**Request for Bid
Humphrey's Blvd CIPP Addendum No. 4 to
RFB No. 426565.71.0435
September 3, 2026**

**Section 1
Additional Bidder Questions Received to Date**

Sideline Sizes

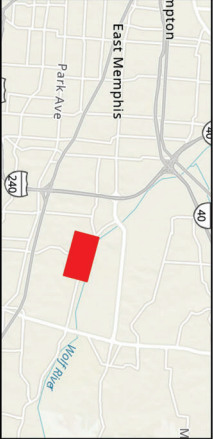
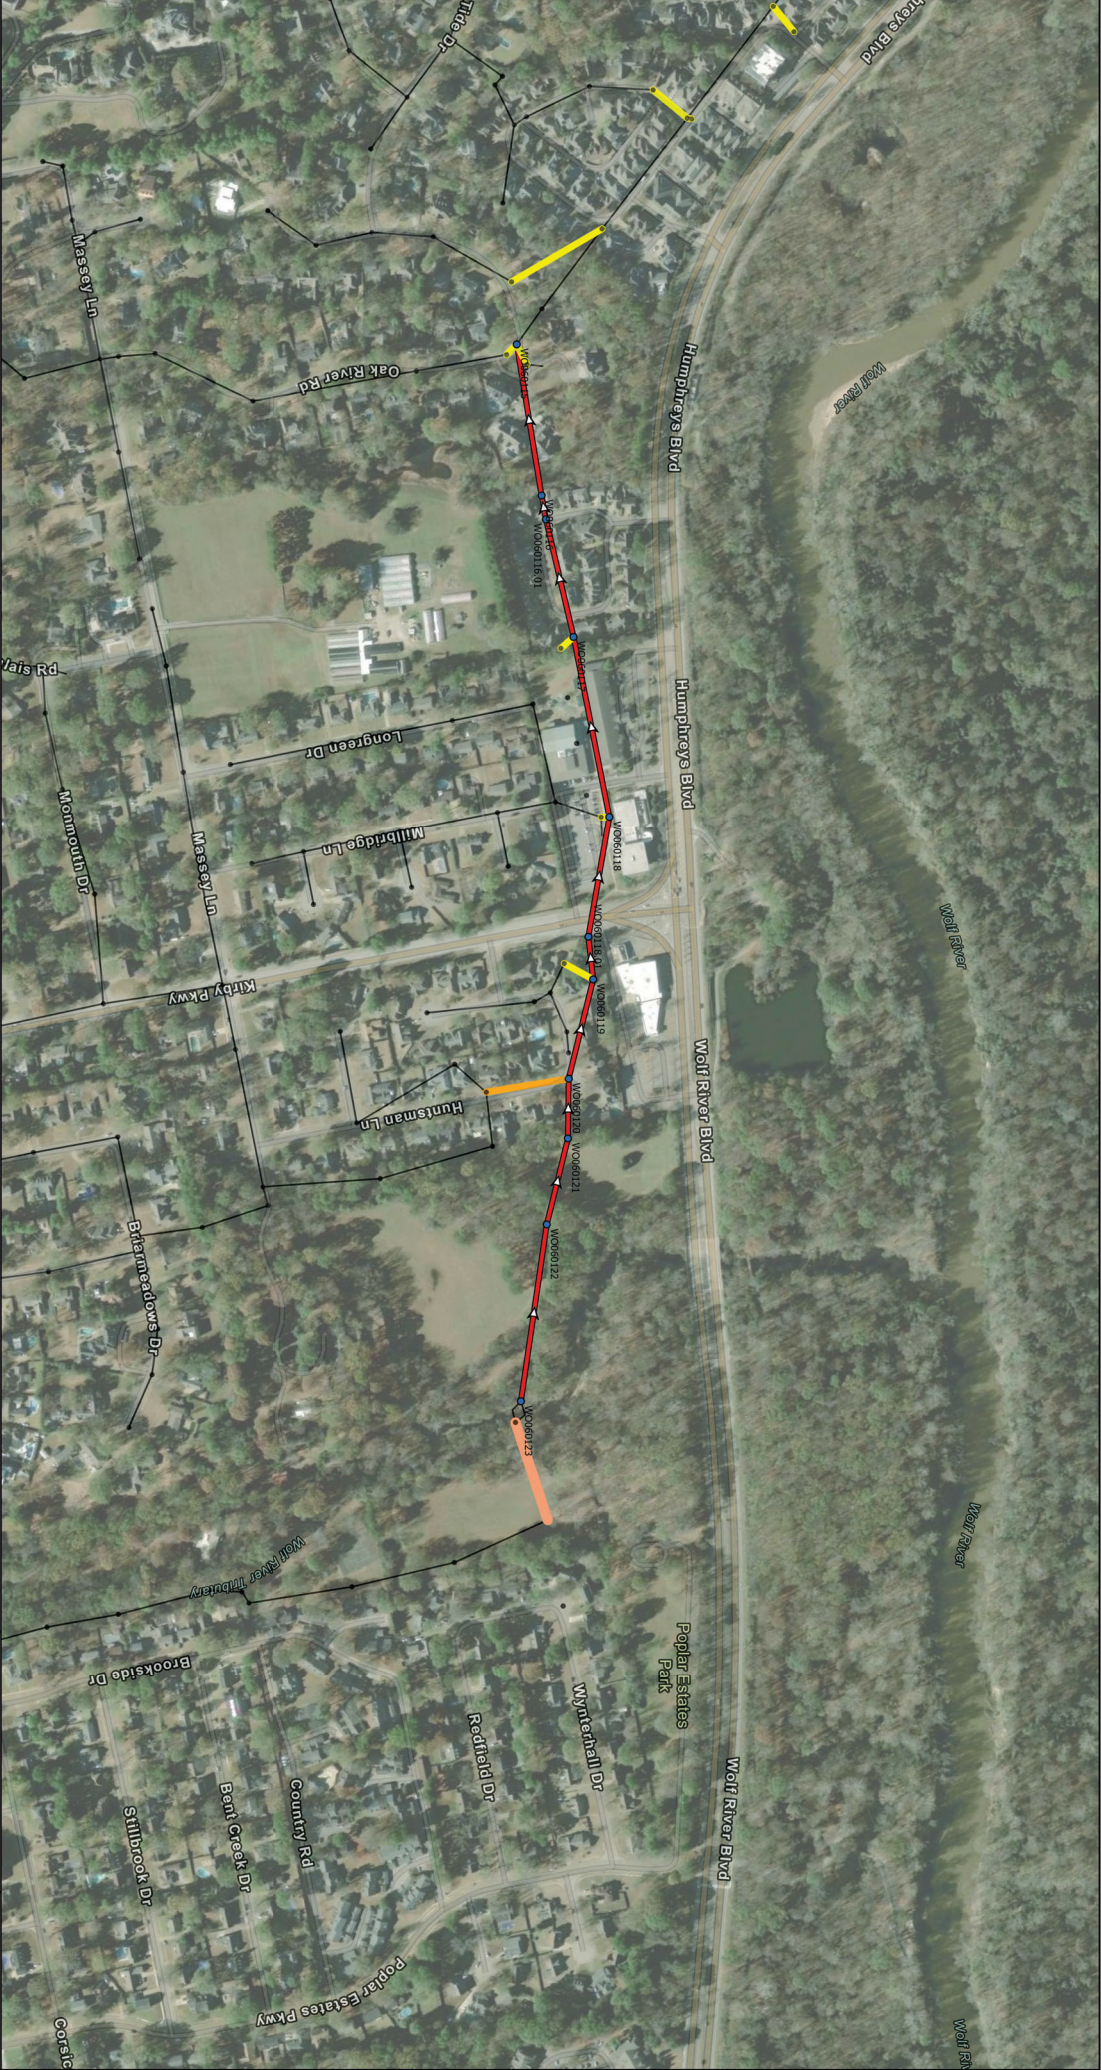
Q5: Please provide additional maps showing the diameters, manhole depths, flow directions, etc. of the adjacent sewer system so bidders can responsibly bid the required bypass pumping?

SARP10: Refer to Addendum No. 4 for a map identifying the sizes of the adjacent sewers.

48" WOLF RIVER INTERCEPTOR RELIEF
 MEMPHIS, TENNESSEE
 DIVISION OF PUBLIC WORKS
 SHEET NO. 2

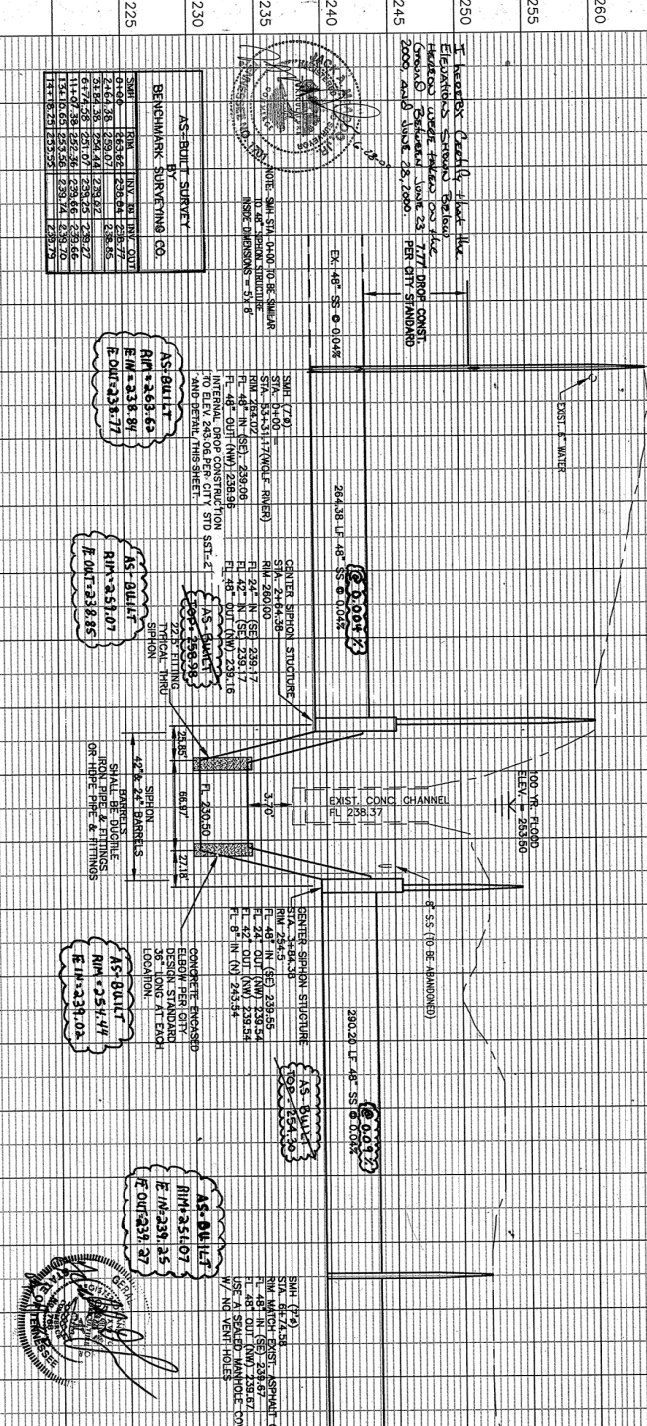
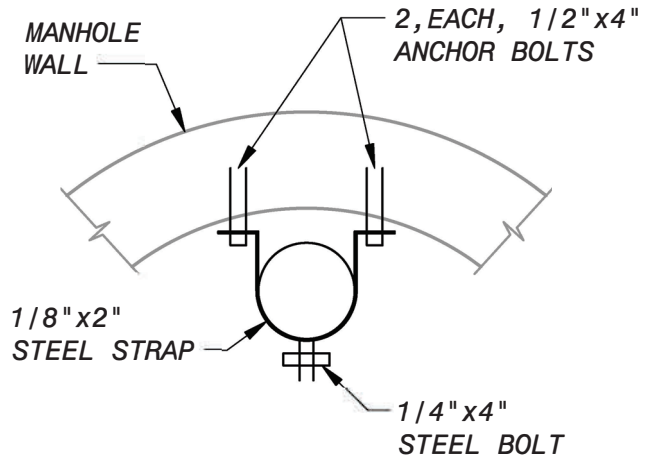
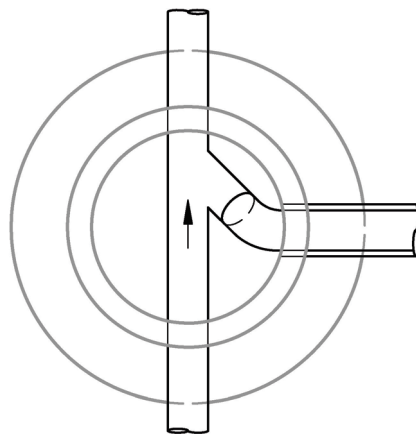
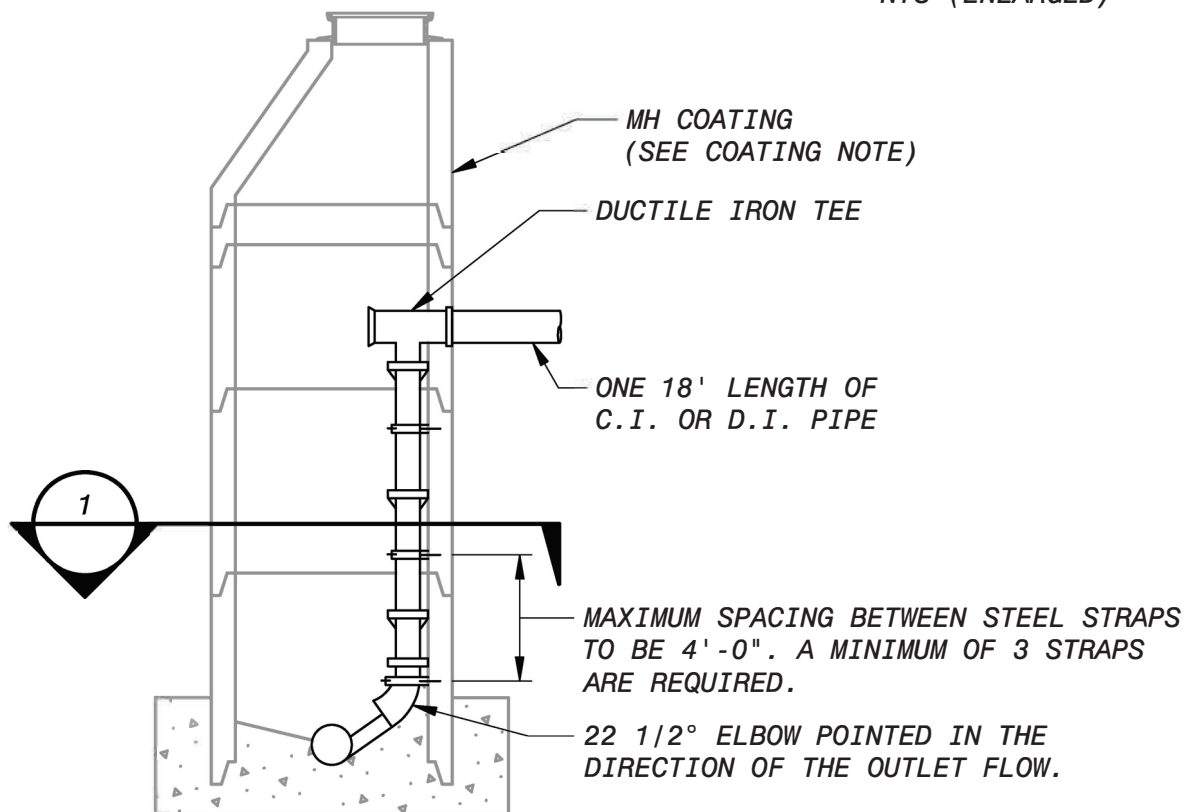
Q3: Please provide as-builts, additional plan and profile drawings with elevations, or additional information of the siphons and their structures to be rehabbed, as well as the siphon at the upstream end of the project?

Q53: Will the Owner provide a detail drawing of MH WO050150? We are requesting this since it appears the line may have gradual 90-degree bend.

SARP10: Refer to Addendum No. 4 for the available information regarding the siphons and associated structures.

SARP10: Refer to the plan set provided in Addendum No. 4 for the available information regarding Manhole WO050150.
